**Temporary Holiday Camp, Place of Recreation, Sports or Culture, Barbecue Site
and Eating Place with Ancillary Facilities and Associated Filling of Land and Pond
for a Period of 3 Years in "Agriculture" Zone,
Various Lots in D.D. 107 and D.D. 109, Fung Kat Heung, Kam Tin, Yuen Long, New Territories**

(S.16 Planning Application No. A/YL-KTN/1253)

DRAINAGE IMPACT ASSESSMENT

Response to Comment Table Based on Comments in
22 September 2026

FIGURE 2

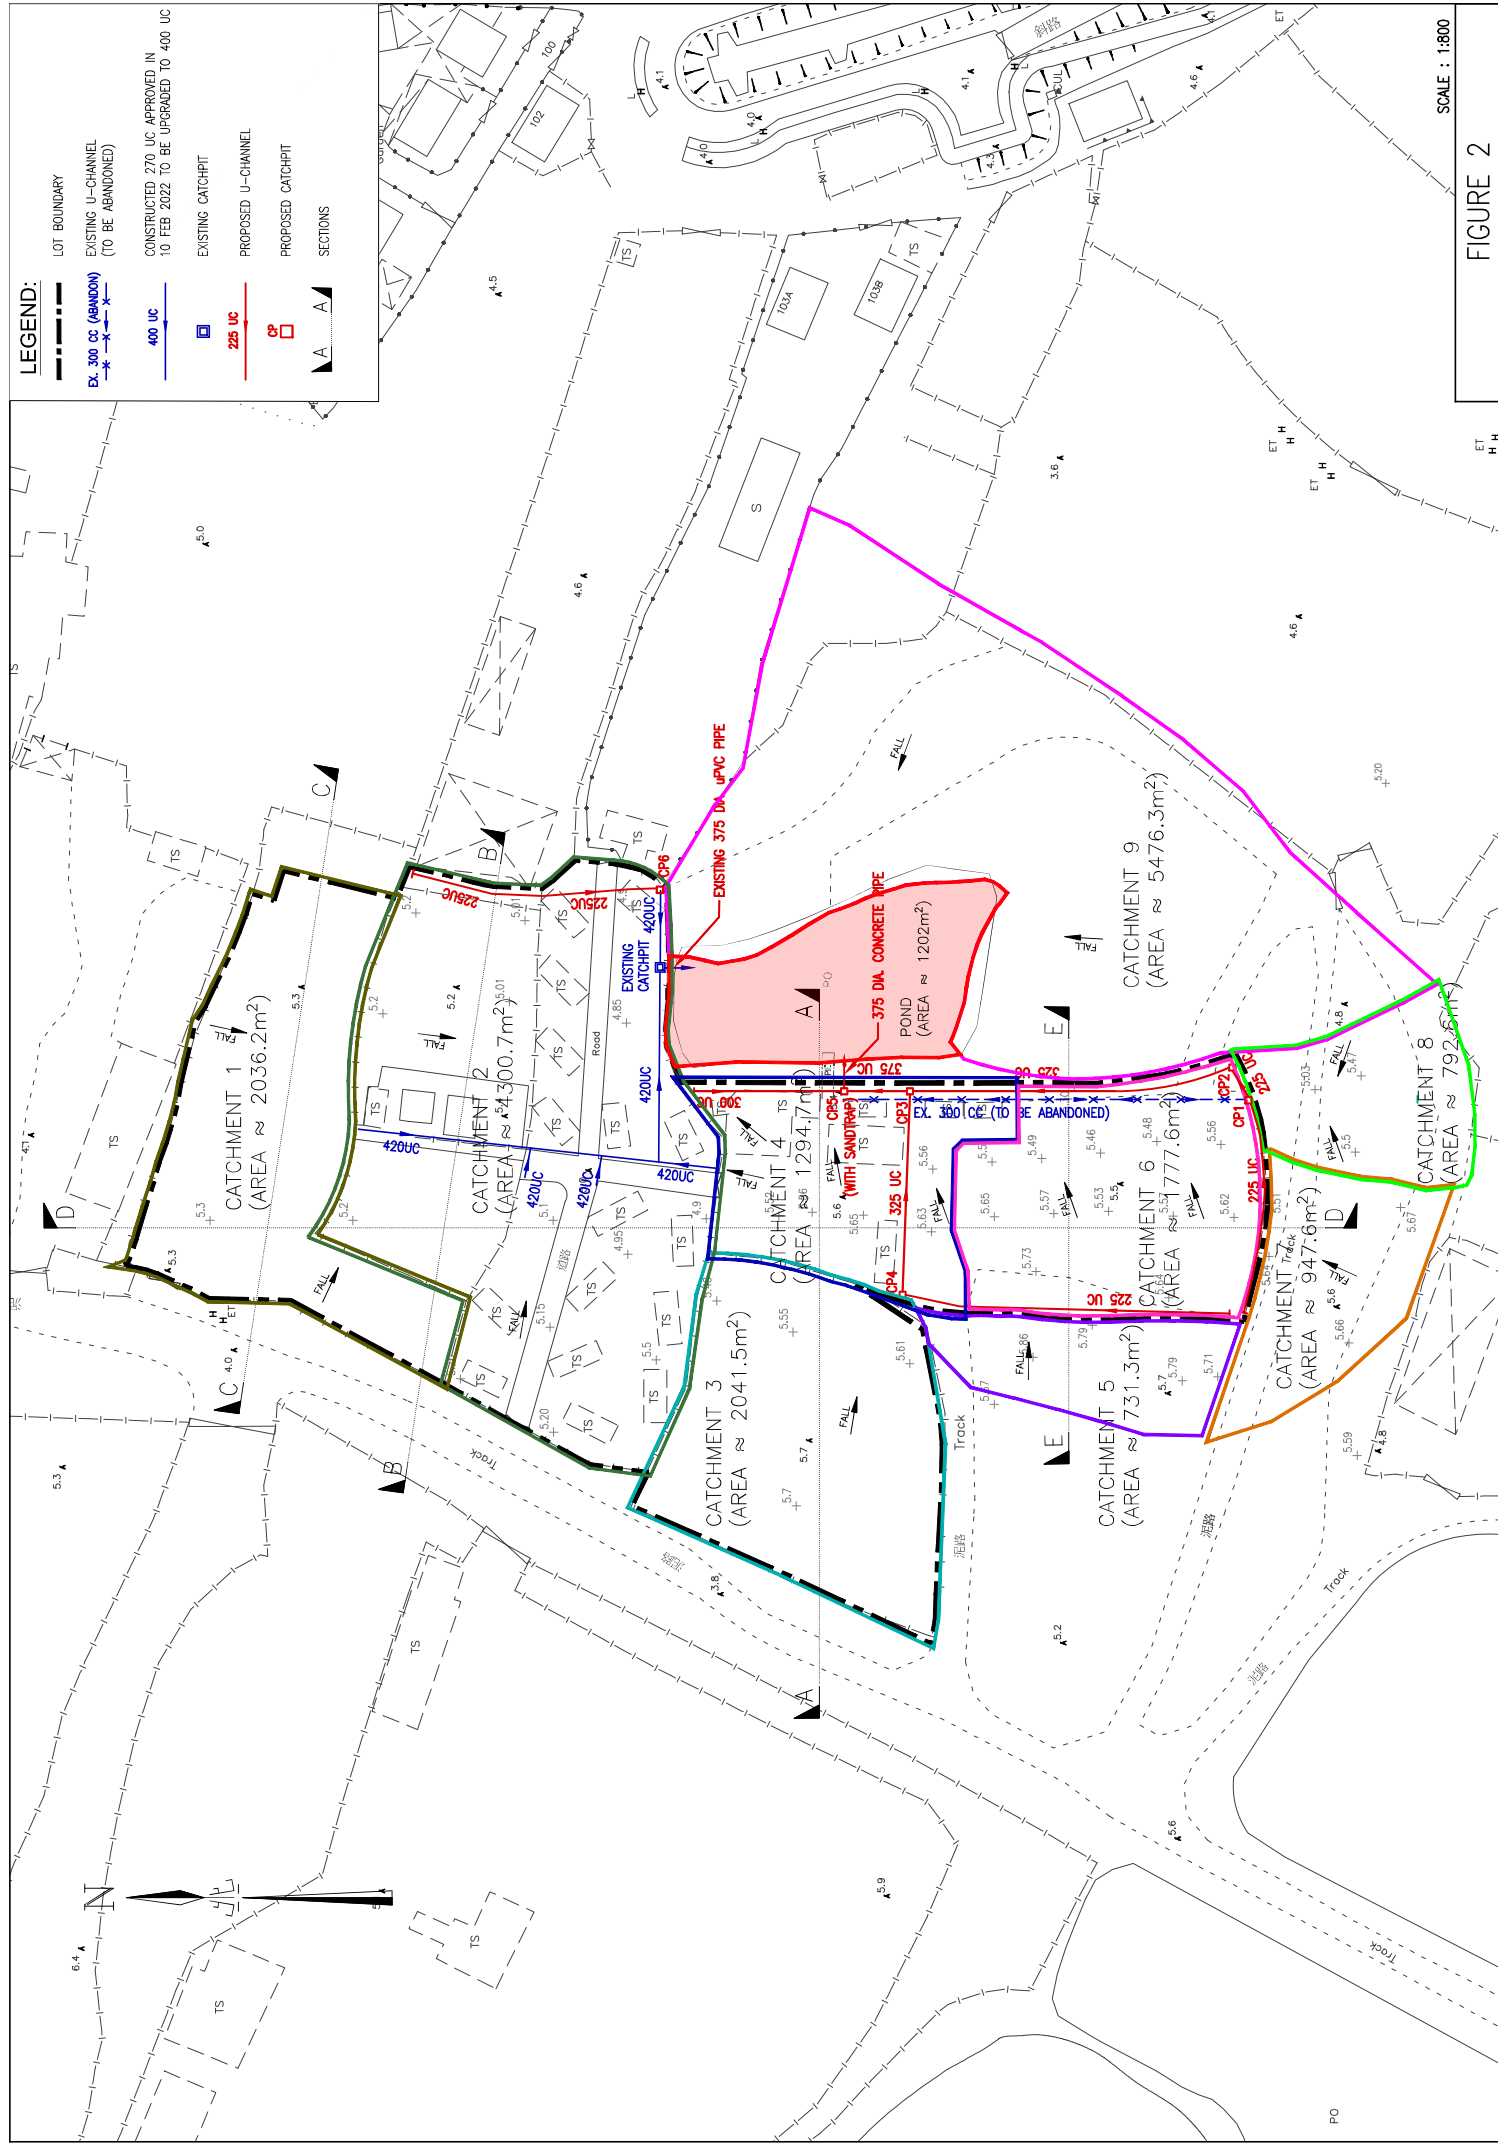
DSD/LD Comment	Response to DSD/LD Comments
(a) Please clarify the discrepancy of the pond area mentioned in September 2025 Report in Appendix F (1202m ²) and Figure 2 in Appendix H (1084.4m ²).	(a) Noted. The pond area is revised to 1202m ² in Figure 2 and related calculation.

FIGURE 3

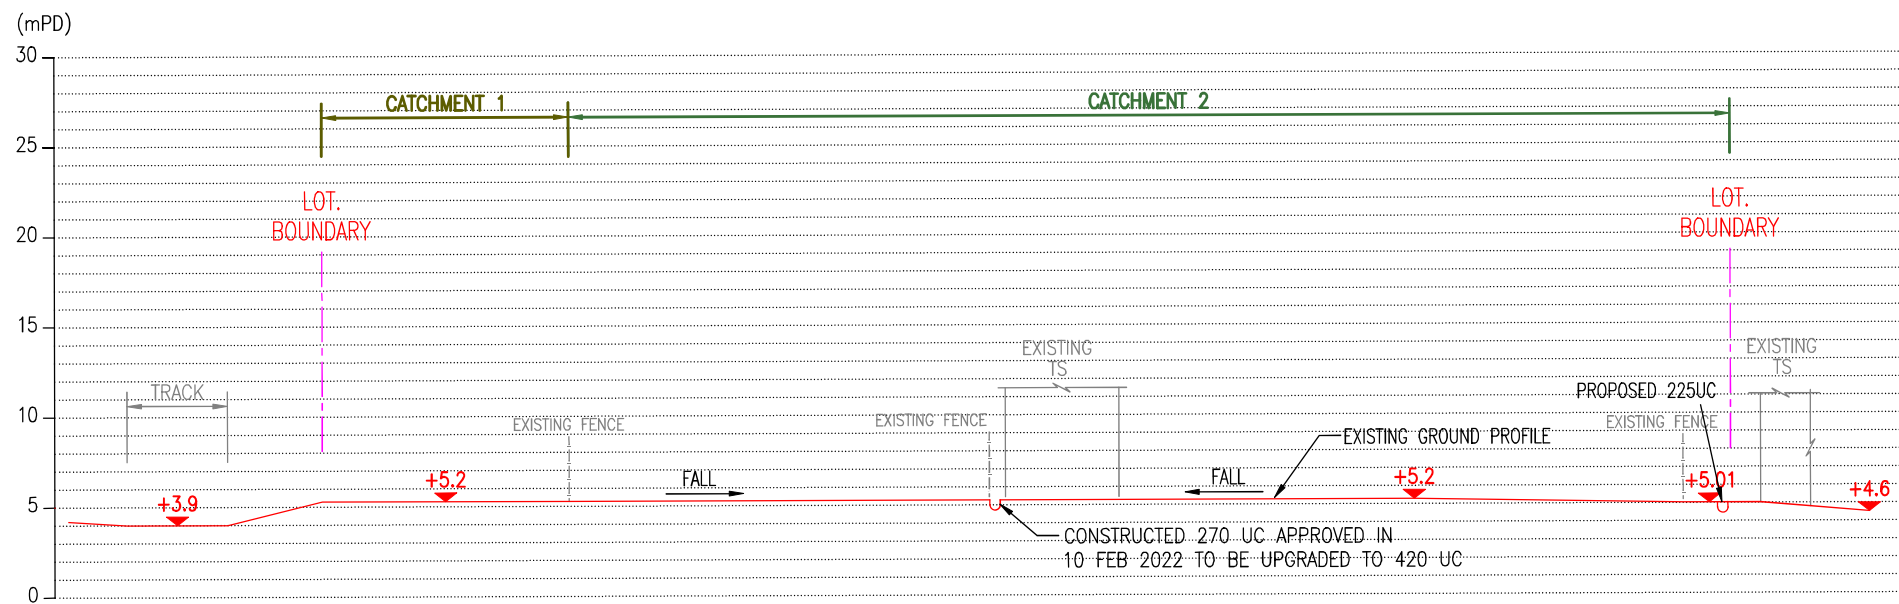
(c) Please review if “Existing 400 UC” as shown on Section B-B in Figure 4 should read “Proposed 400UC”.	Noted. “Existing 400UC” is revised to “CONSTRUCTED 270 UC APPROVED IN 10 FEB 2022 TO BE UPGRADED TO 420 UC”

(d) As shown on Section B-B, the existing ground level is higher than the area at the right. Please provide peripheral surface channel to collect the surface runoff accrued on the application site.	Noted. A 225mm peripheral channel is proposed at east of Catchment B to collect the surface runoff

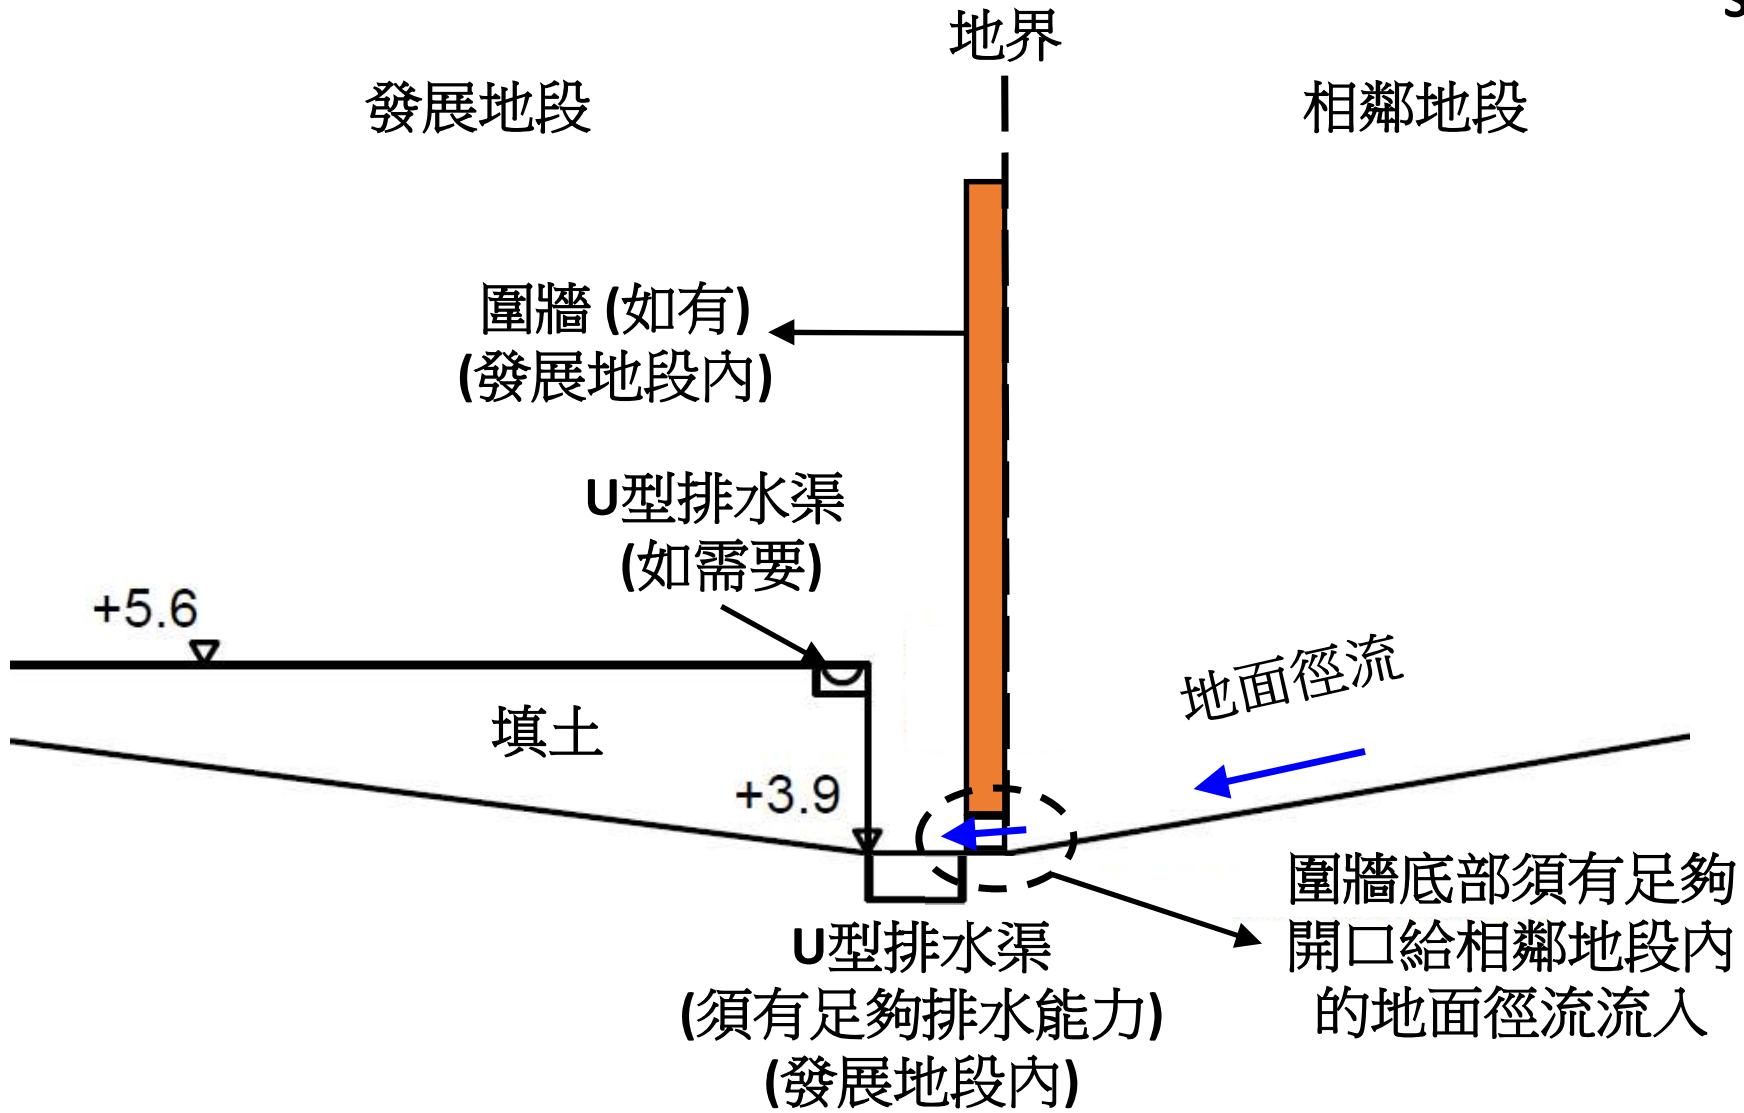
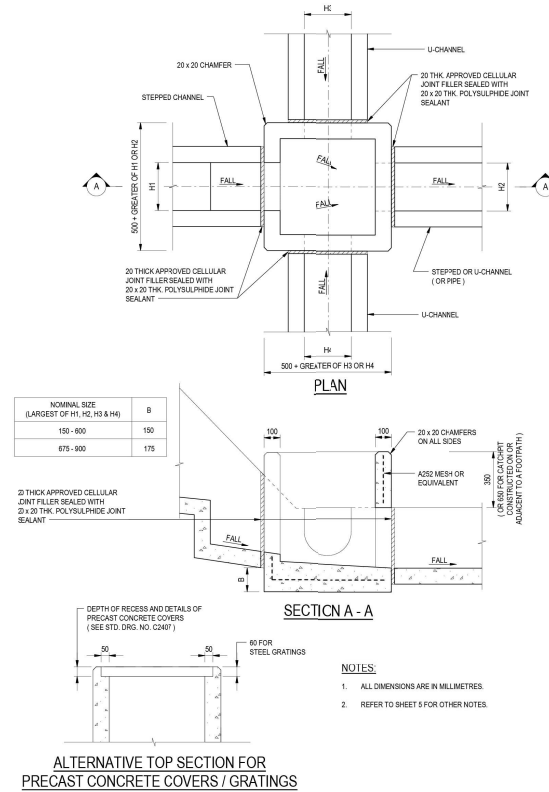
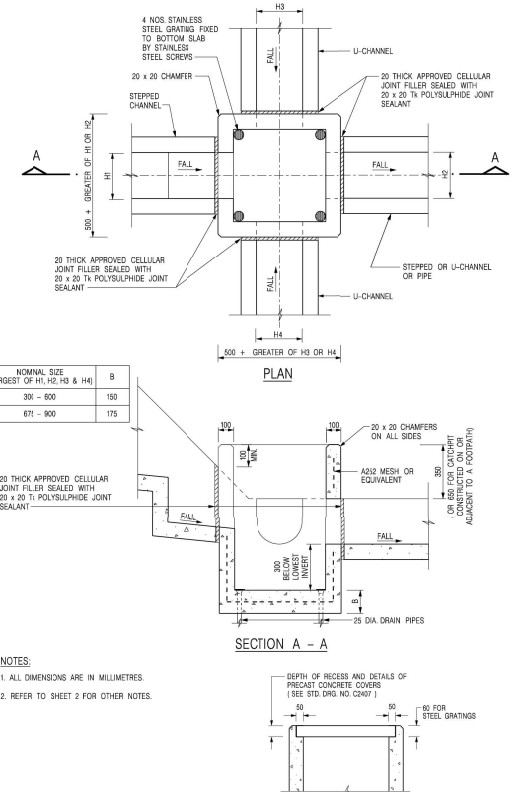
(f) Please provide the connection details at the discharge point and indicate details (e.g. cover level, invert level and watercourse bottom level) in the drawing.	Noted. The connection detail is provide in Fig. 8 for reference.

(m) The details of catchpit with sand trap or provision alike was indicated on Figure 8 in Appendix H. However, the feature of catchpit with sand trap was not clearly indicated on plan and legend. Please review.	Noted. The catchpit with sandtrap (CP5) is indicated on plan and catchpit schedule.
